COUNTY OF SAN MATEO
PLANNING AND BUILDING DEPARTMENT

DATE: May 27, 2009

TO: Planning Commission

County File Number: PLN 2005-00603 (Ehteshami)

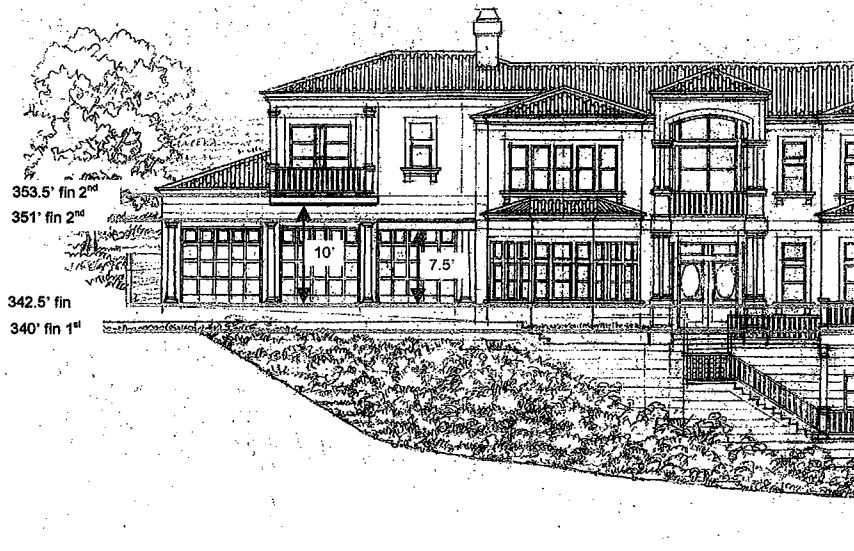
- The design of the house can not be built with the proposed elevations. The figure A below is of the second floor with the elevation of the finished floor color coded – Pink 351' and yellow 353.5'. If you take a cross section at the red line through the bathroom, you get the Figure B.

This shows that there is only 7.5' of clearance in the garage below the subflooring and joists. Additionally the right edge of the second floor is designed to be supported by the pillars of the garage. The following is a view of the front of the house with the impact of this issue:

Getting the necessary clearance in the garage and for the front elevation with pillars (etc), will impact either the overall height of the house pushing the height limits (currently at 26') or require more grading to occur to lower the finished level of the garage.

Height Study

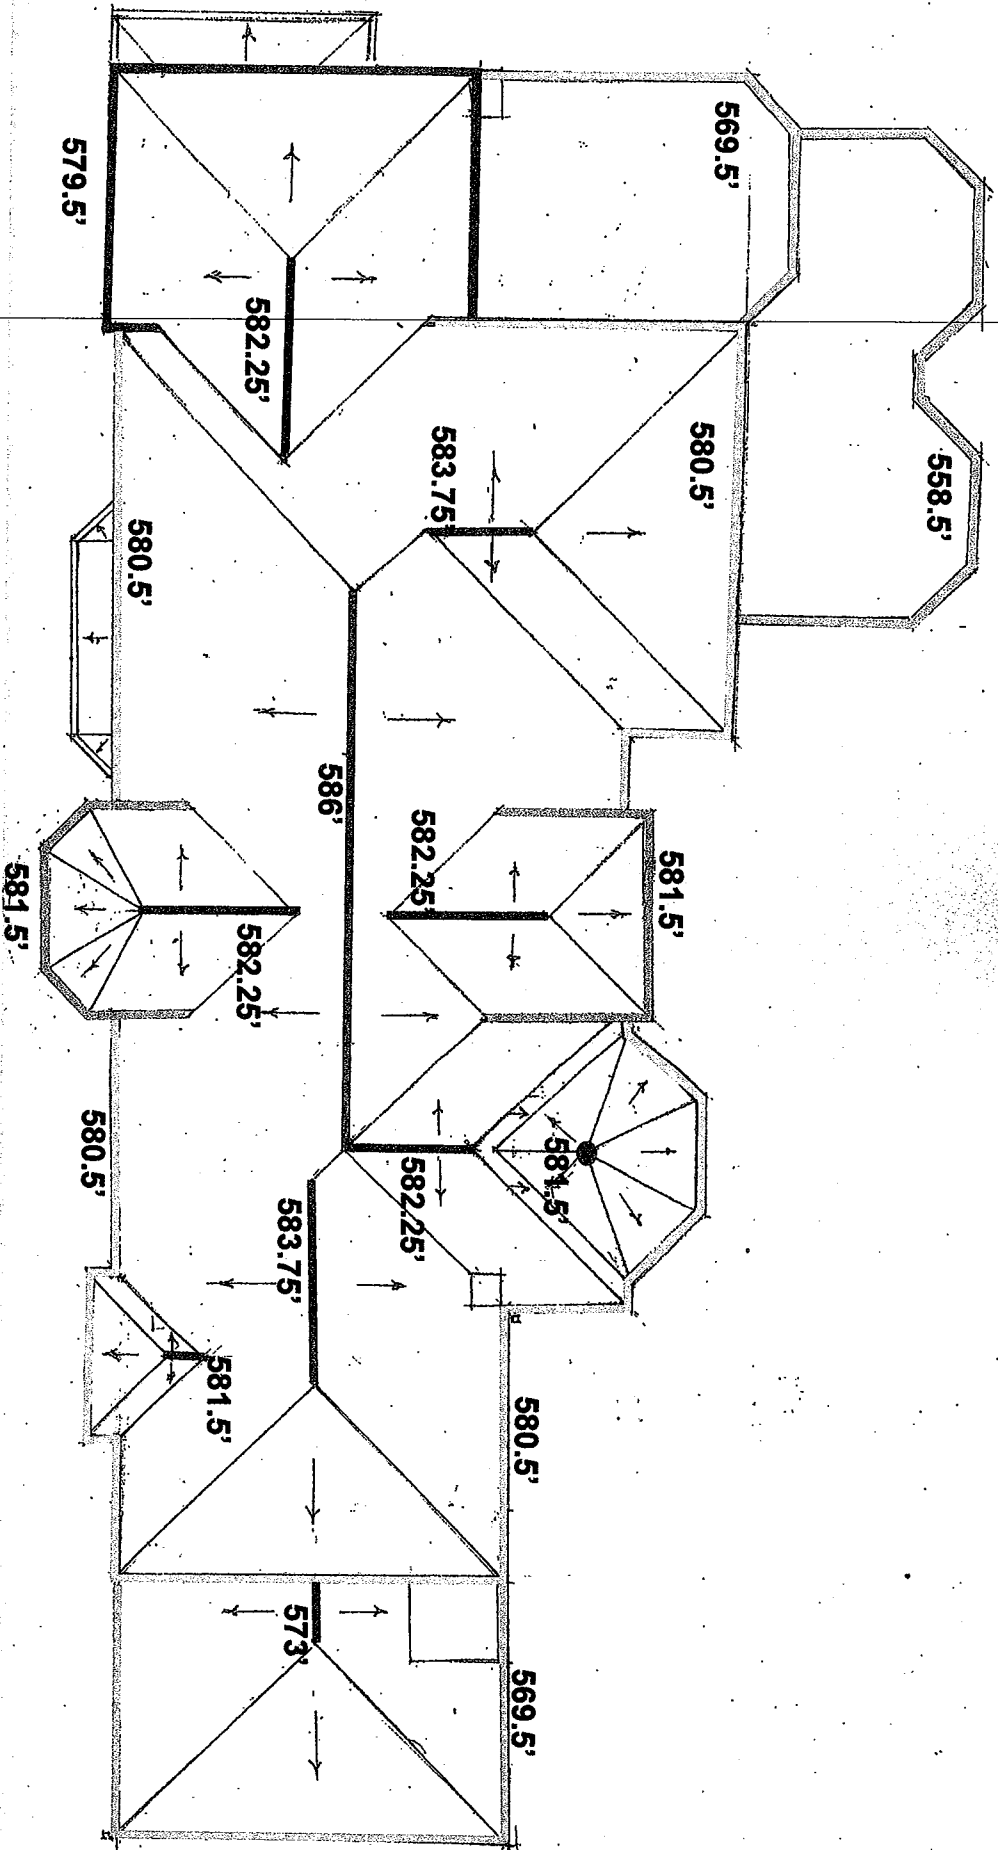
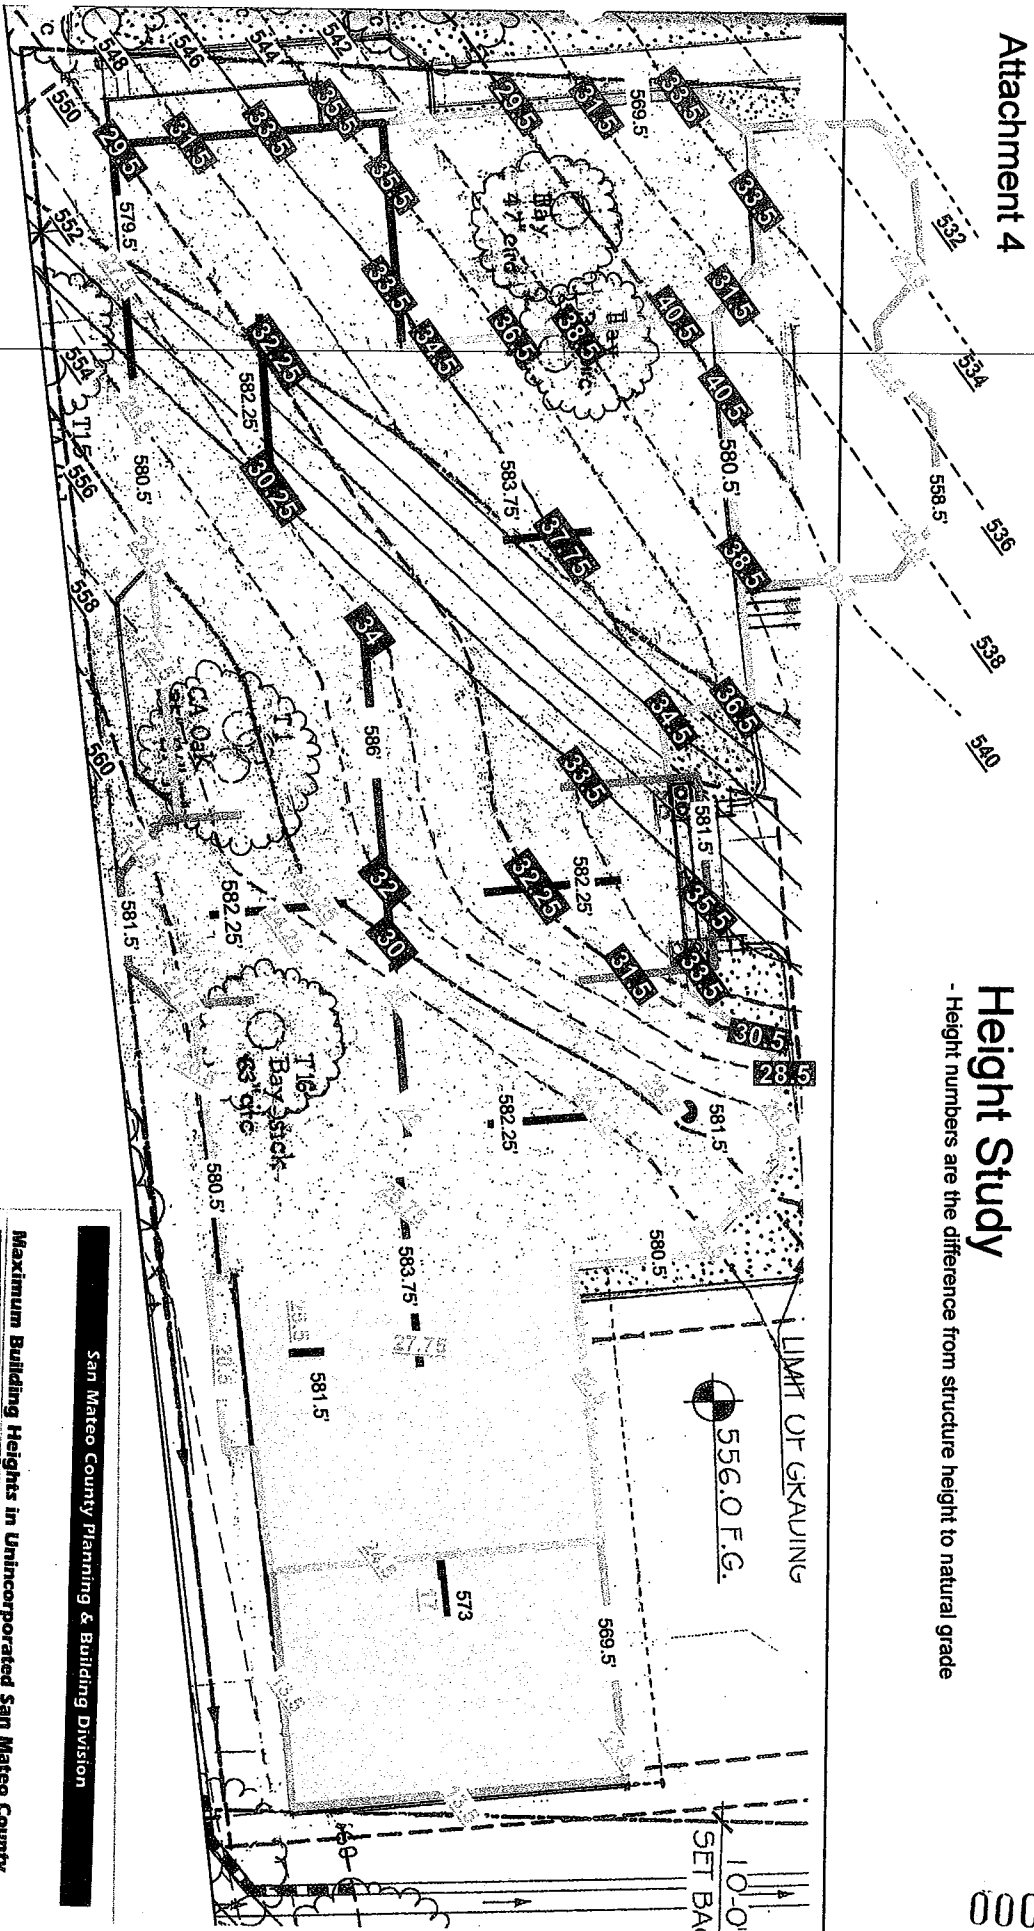
To investigate the height issue further, we took the structure height data from Attachment 4 and applied them to the West Elevation (Attachment 5), North Elevation (Attachment 6), and cross sectional view A/A2.1 (Attachment 7) to determine where the true grade should be on these drawings. In each case the actual grade is much lower than that shown in the drawing. *This results in a lower 28' maximum height line through the structure than the one shown on the drawings.*

West Elevation Study

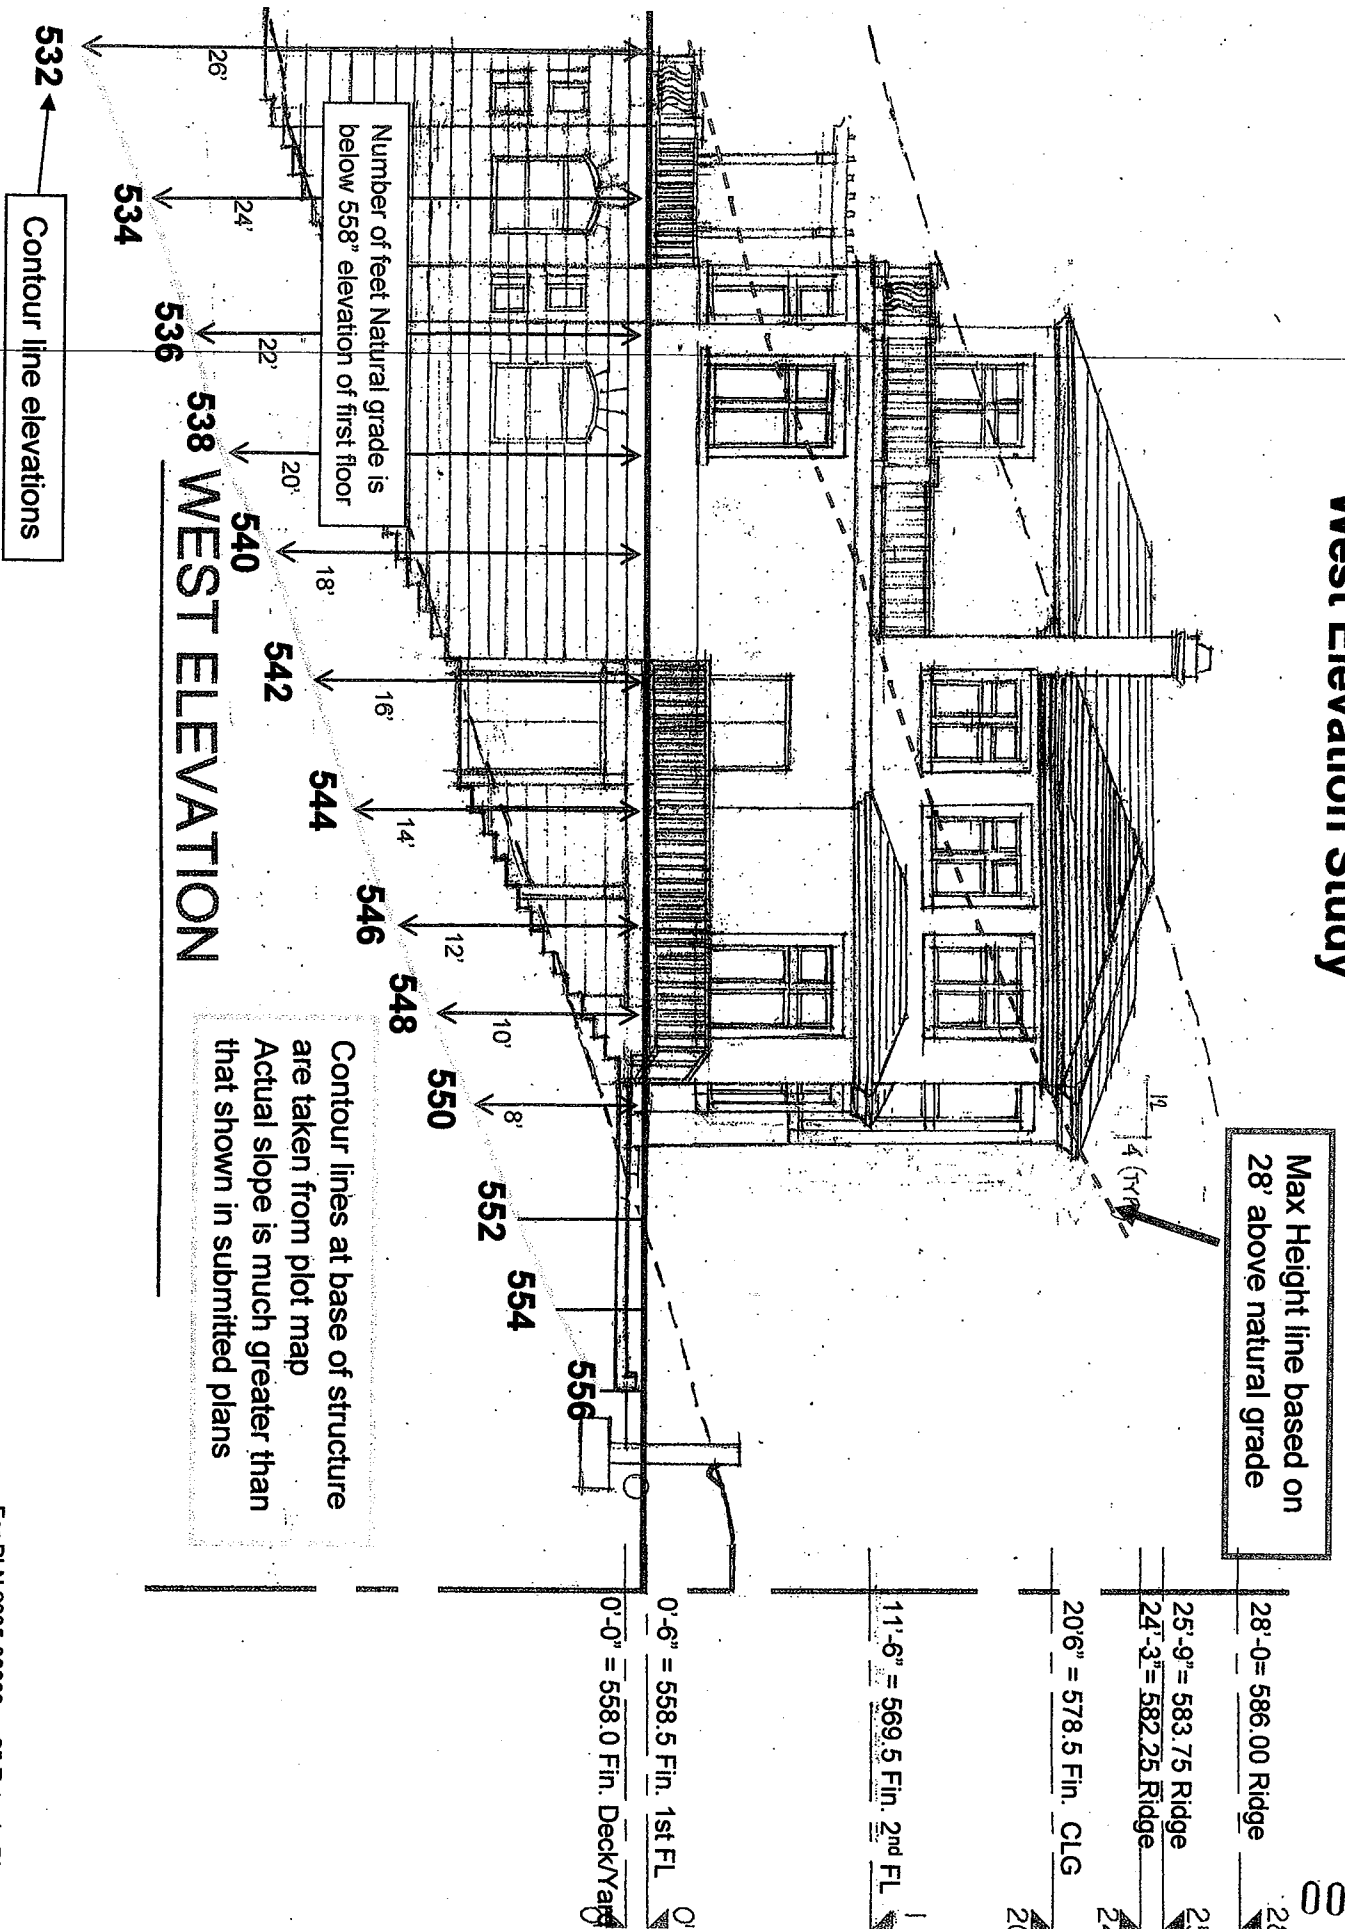
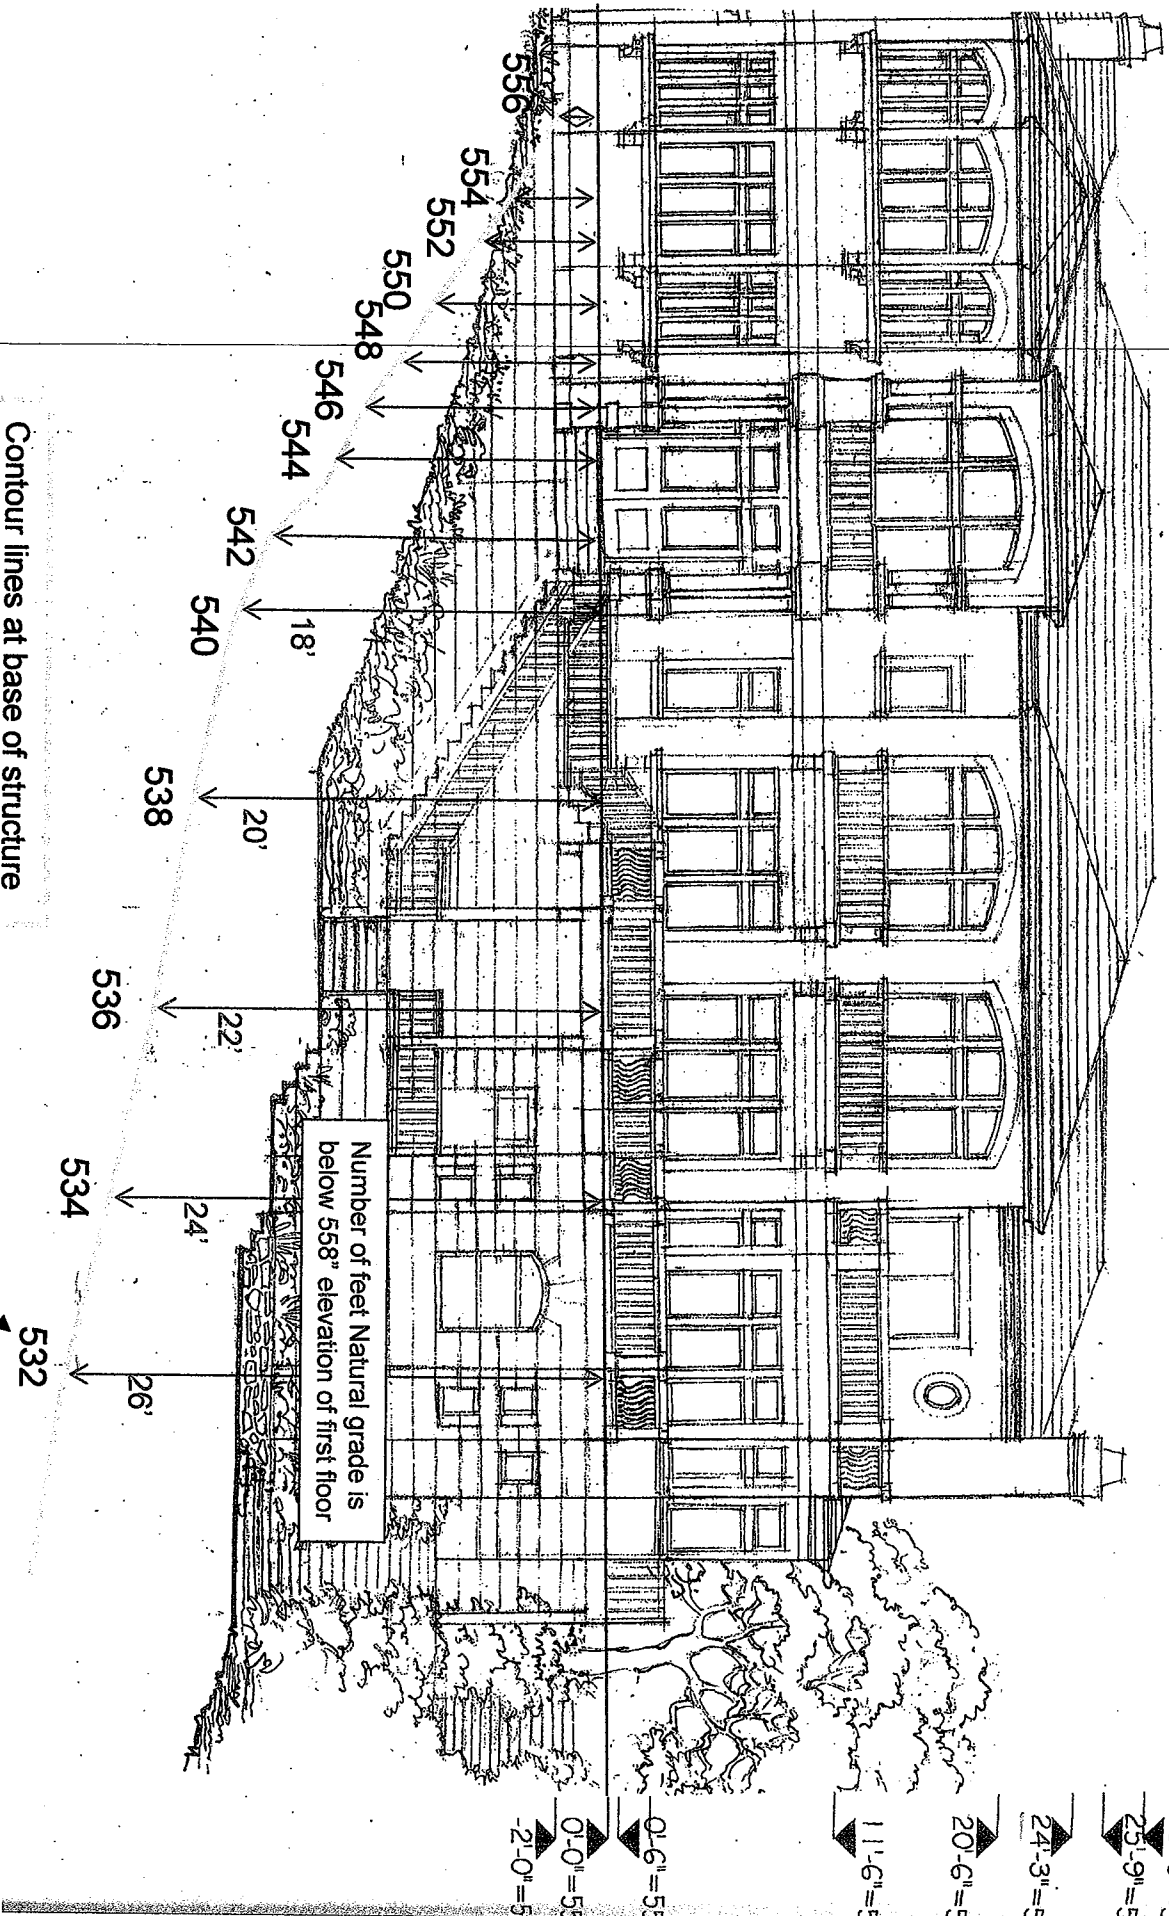
Max Height line based on 28' above natural grade

Number of feet Natural grade is below 558" elevation of first floor

Contour lines at base of structure are taken from plot map. Actual slope is much greater than that shown in submitted plans
